CITY OF JOPLIN
Interior Renovations Joplin City Hall

Addendum No. 1

2. Plan sheets 1, 3 and 6 have been revised. See attached plan sheets for project revisions.

SECOND FLOOR PLAN

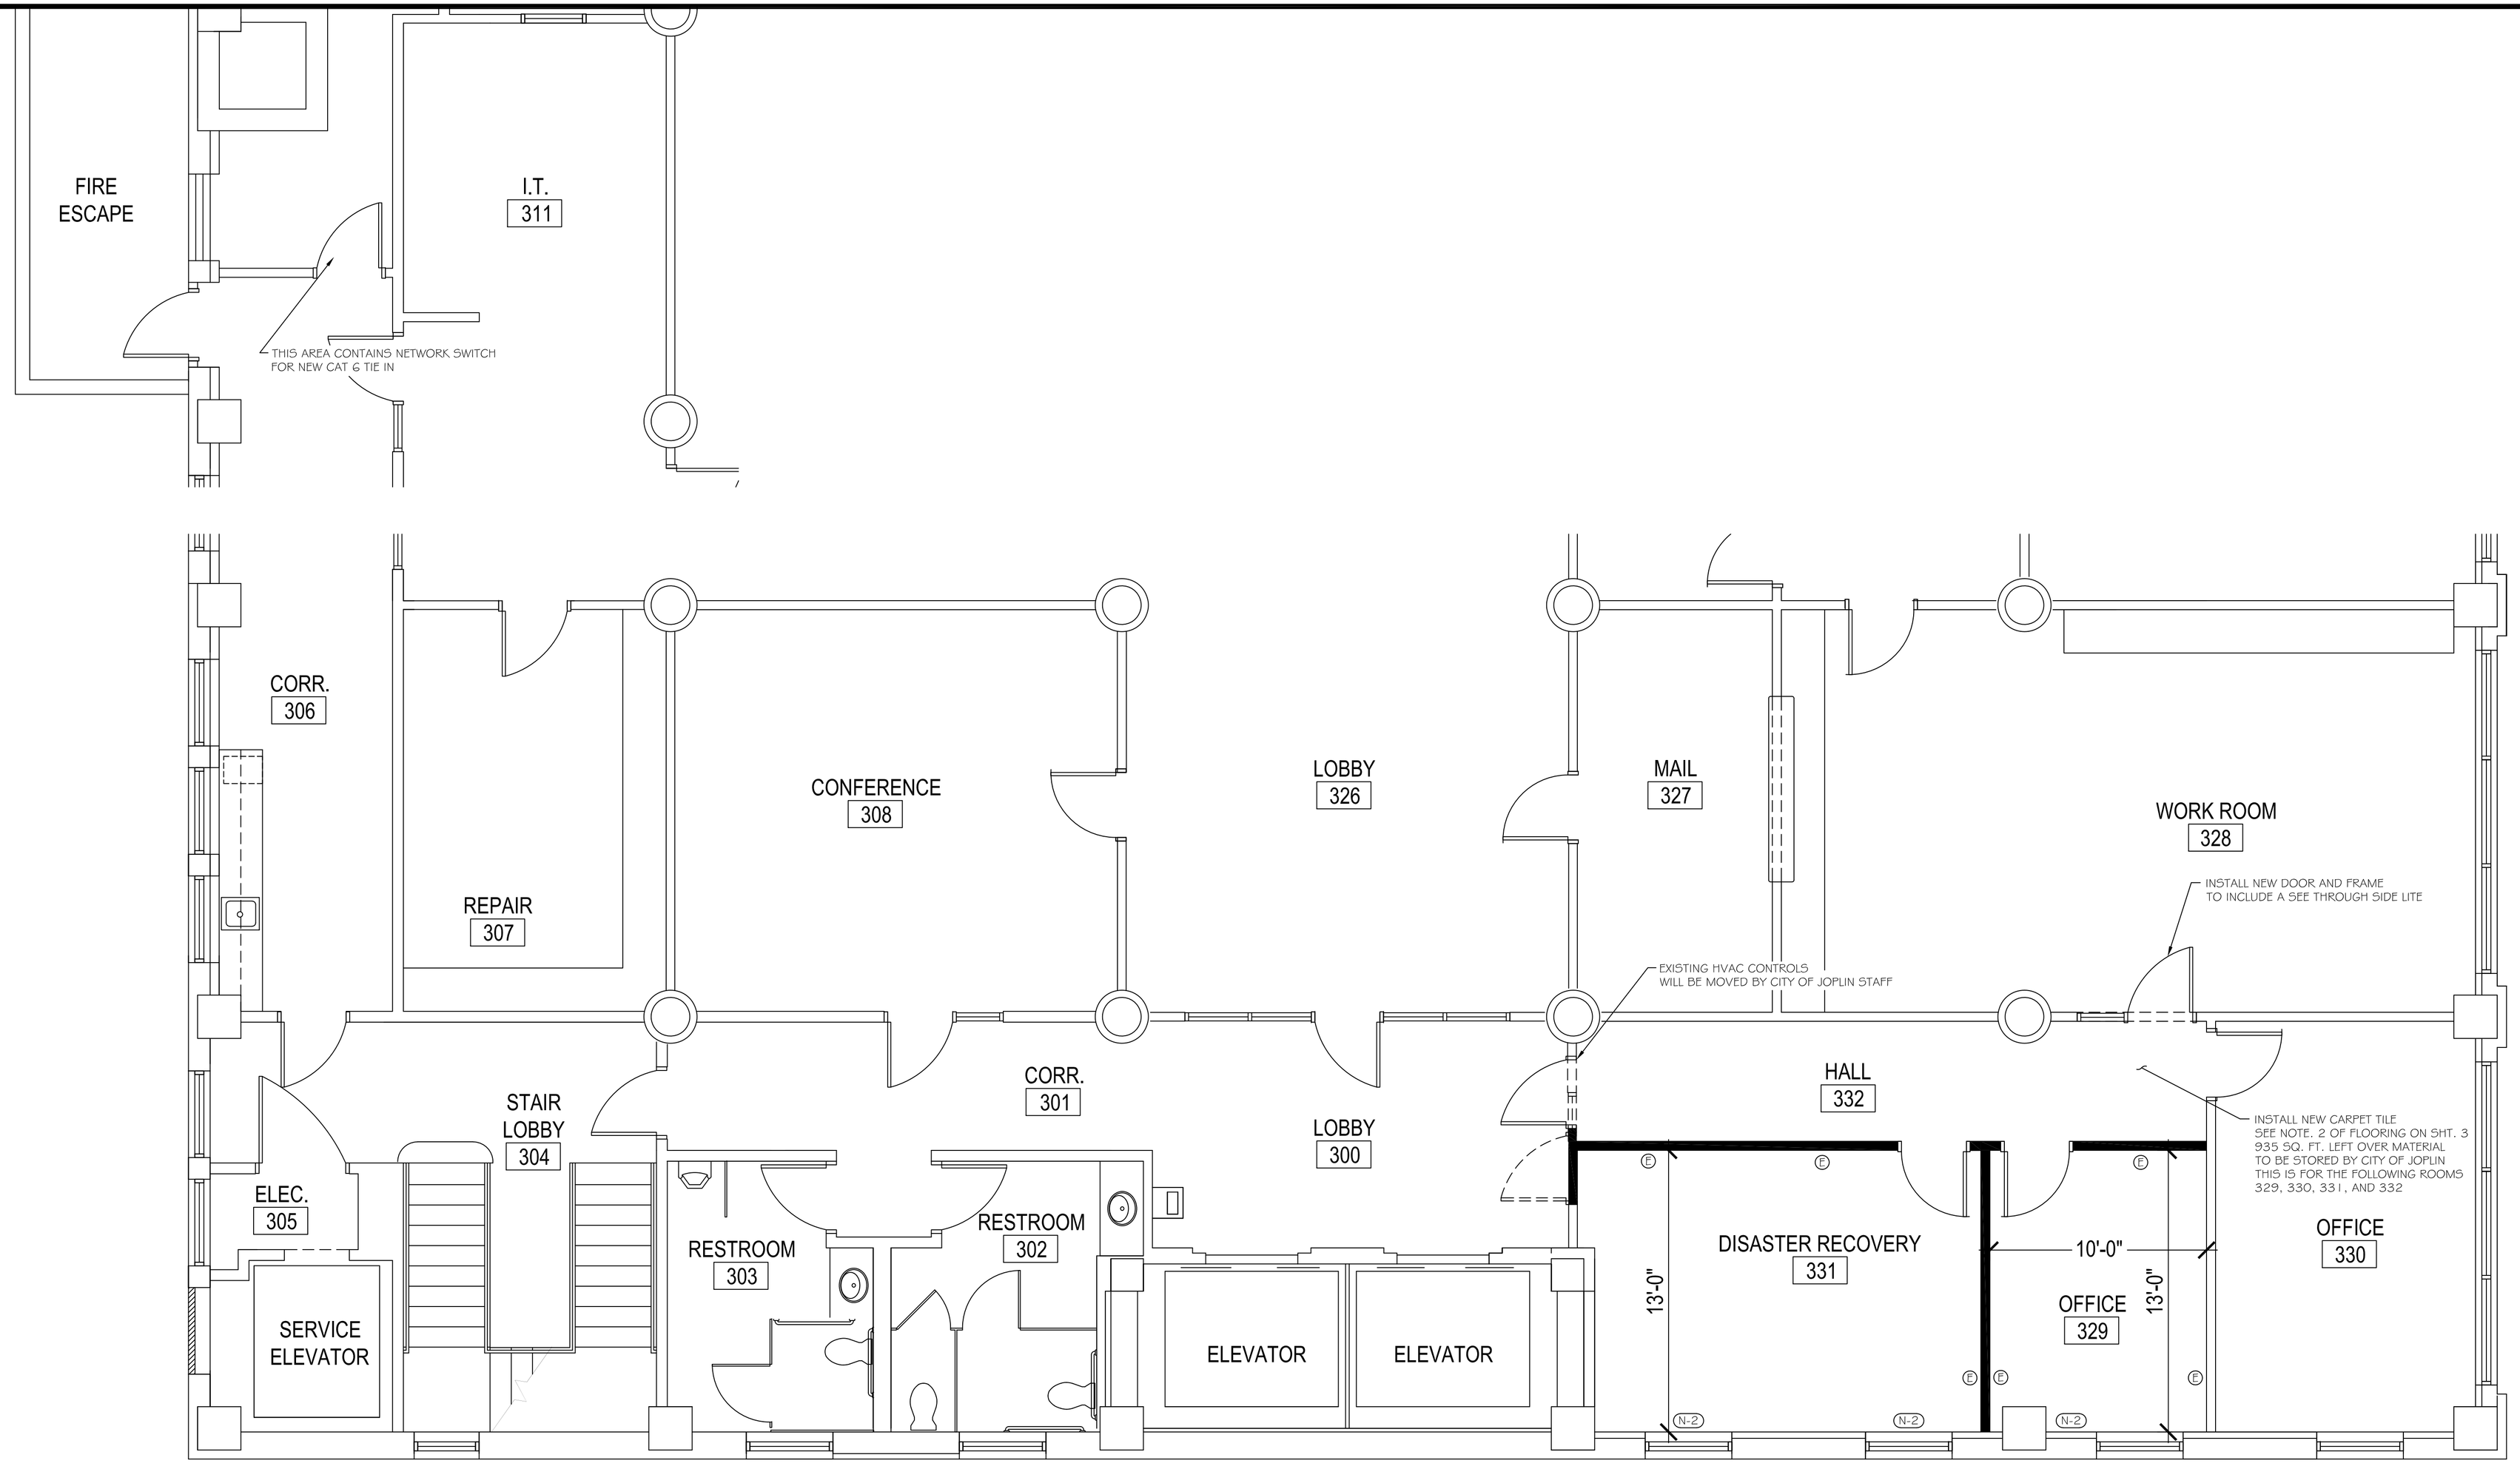
3. **There are no light switches shown on the plans for the newly created offices?**
   a. Please see the revised plans.

1
OFFICE LIGHTING IN THE FOLLOWING ROOMS TO HAVE SWITCHES INSTALLED TO CONTROL LIGHTING INDEPENDENTLY
225,233, AND 236
